**Remediation System Evaluation (RSE)**  
**Moss-American Superfund Site**  
**Milwaukee, Wisconsin**

# REMEDIATION SYSTEM EVALUATION MOSS-AMERICAN SUPERFUND SITE MILWAUKEE, WISCONSIN

Final Report  
March 2011

Prepared for:  
US Environmental Protection Agency  
Region 5

Figure A-9. New Gate West of MW-7S, Excavation at MW-34S

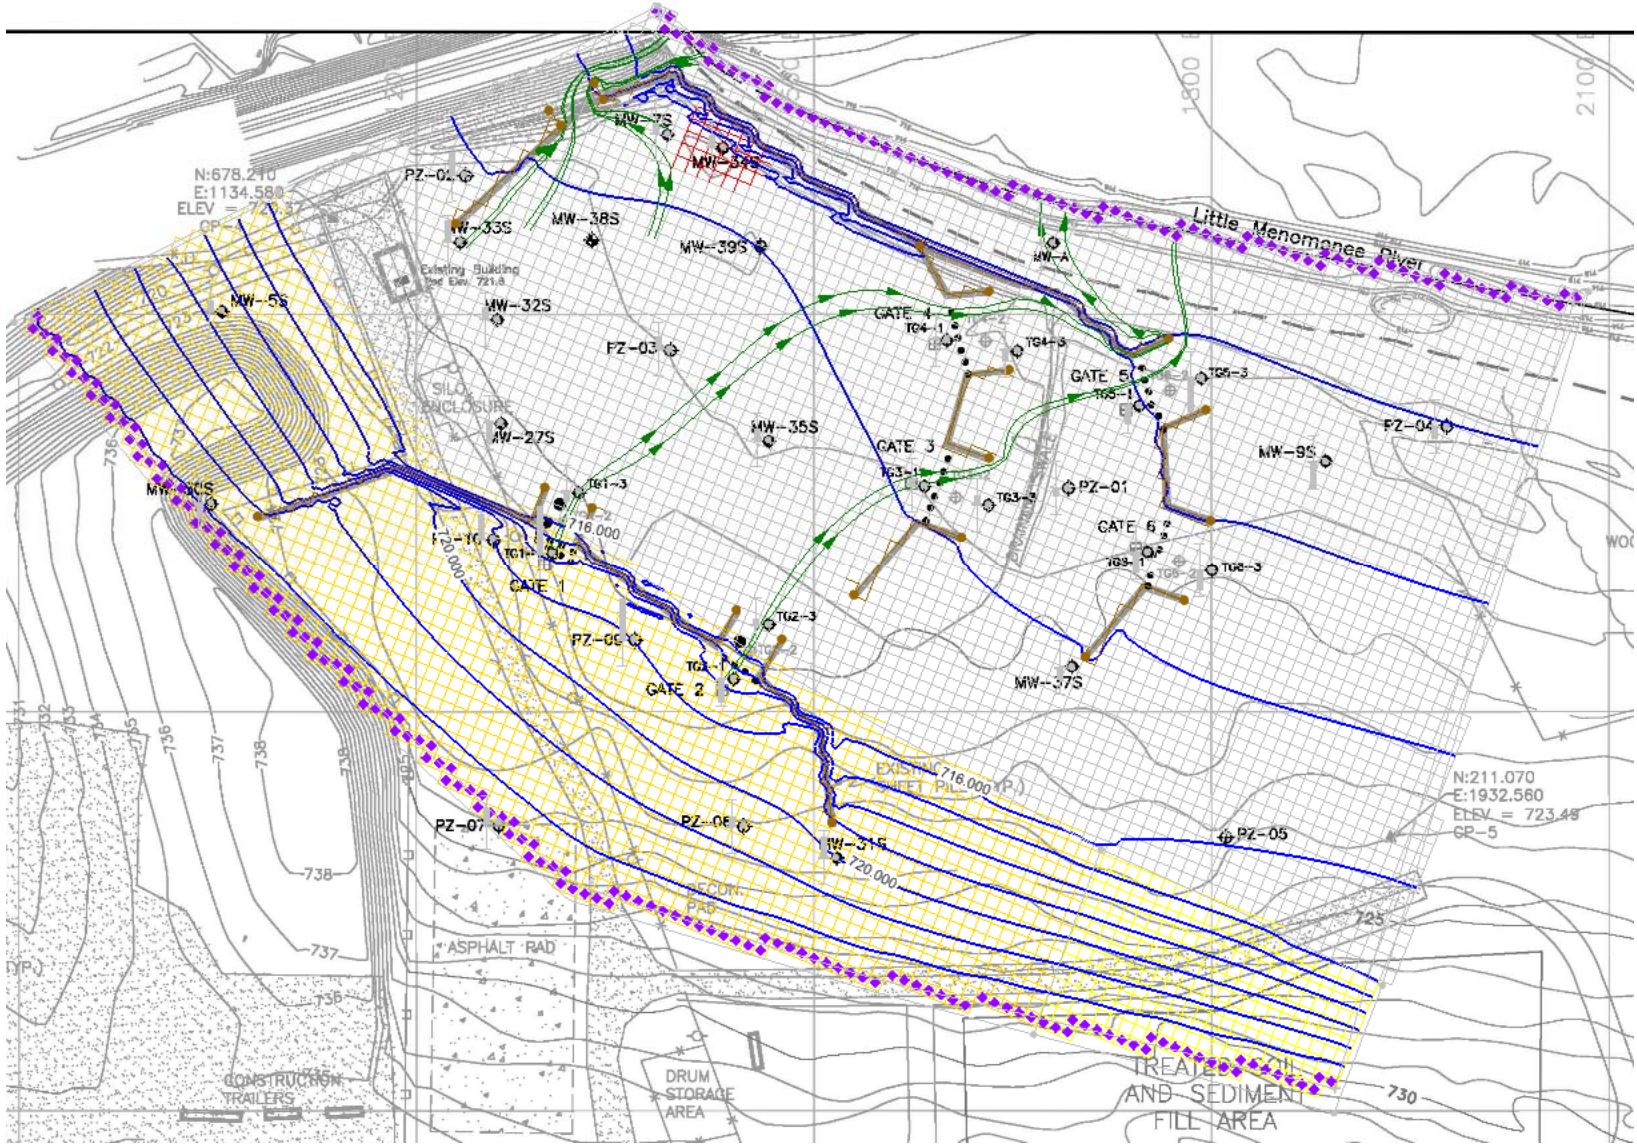
Figure A-9 shows the groundwater elevation contours for a new gate west of MW-7S and excavation at MW-34S. This scenario includes excavation of NAPL containing soils around MW-34S (shown in red on Figure A-9) and backfill with sand and ORC. A new gate with air injection treatment would be installed to the west of MW-7S. The model shows that flow is induced toward the gate from the area of stagnation and near MW-33S where groundwater is potentially migration around the end of the sheet pile. This new gate configuration shows that groundwater flow from the up-gradient Gates 1 and 2 still flows toward the eastern gates.
